SUBJECT: Adoption of the Initial Study / Mitigated Negative Declaration and Mitigation Monitoring and Reporting Plan for the Huff's Corner Levee Raise & Channel Reconfiguration Project

Responses to Comments & CEQA Mitigation Monitoring and Reporting Program

Huff's Corner Levee Raise & Channel Reconfiguration Project
Yolo County, California
SCH #2021050214

Figure 3.1-5
With Proposed Project: Difference in Flood Surface Elevation under the 100-Year Flood Event

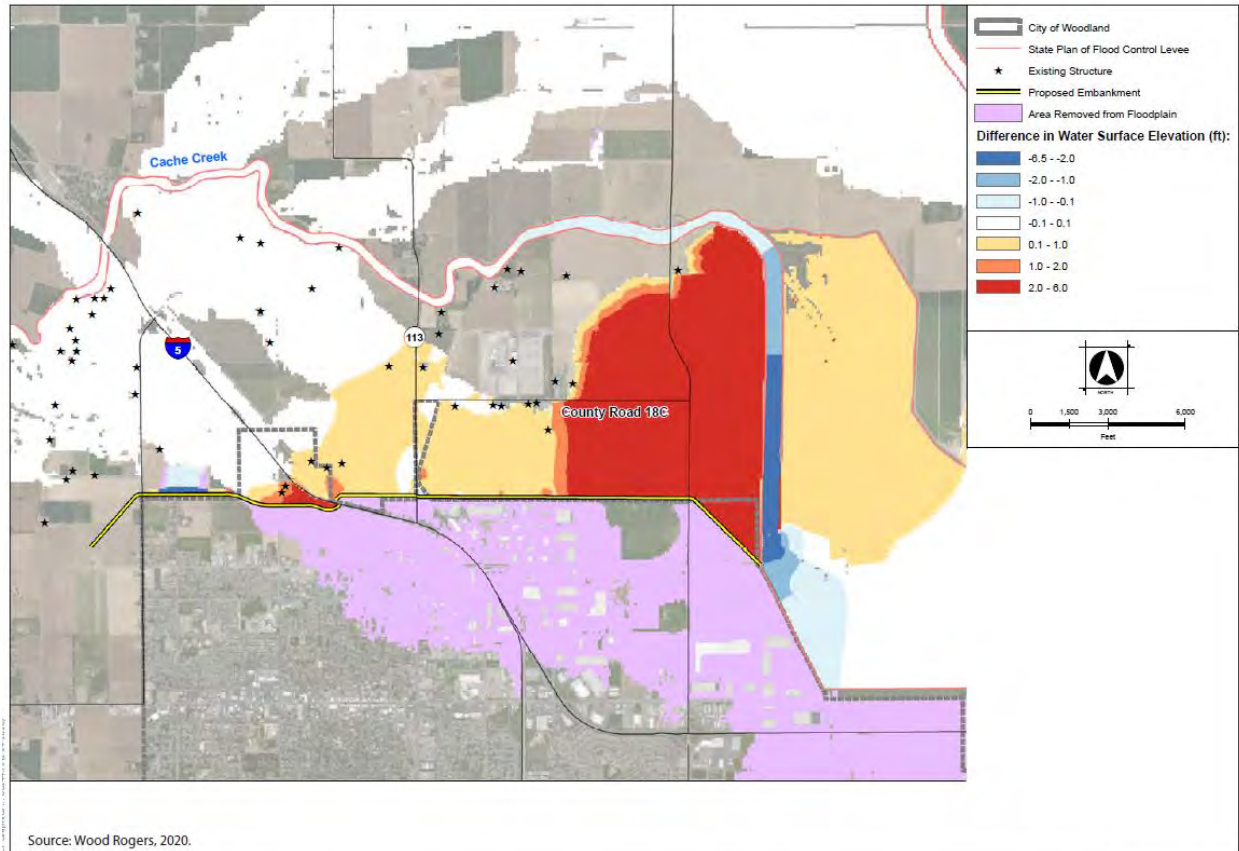
- Currently there is also a proposed project being put forth by the City of Woodland to erect a flood control levee (Flood Wall) to provide 200 year flood protection for the City of Woodland. Has the engineer reviewed what impacts these two projects would have on our properties if both were constructed? If this levee is raised and a flood wall constructed, the waters would overtop behind the homes on County Road 97A (as they do now) and create a flood water bypass for all the properties north of the flood wall, including ours.

The potential for increased inundation was evaluated by comparing with-project and existing conditions within the project area. Figure 3.1-5 shows the differences in water surface elevations with the inclusion of the Proposed Project elements for the 100-year flood. Figure 3.1-6 shows the differences in water surface elevations with the inclusion of the Proposed Project elements for the 200-year flood. As shown in the figures, flooding is no longer present south of the proposed levee (i.e., the city limits), thus meeting the overall project objectives of providing 200-year flood protection and obtaining FEMA certification for the City.

The hydraulic modeling utilized for this analysis assumed that the Huff's Corner levee was at its designed elevation and therefore inherently includes the cumulative impact if both projects are implemented. The location of the commenter is adjacent to Cache Creek in the "white" zone, which shows a difference in water surface elevation with incorporation of the LCCFS Project as -0.1 to +0.1 feet. This does not alter the conclusion for the Huff's Corner project.
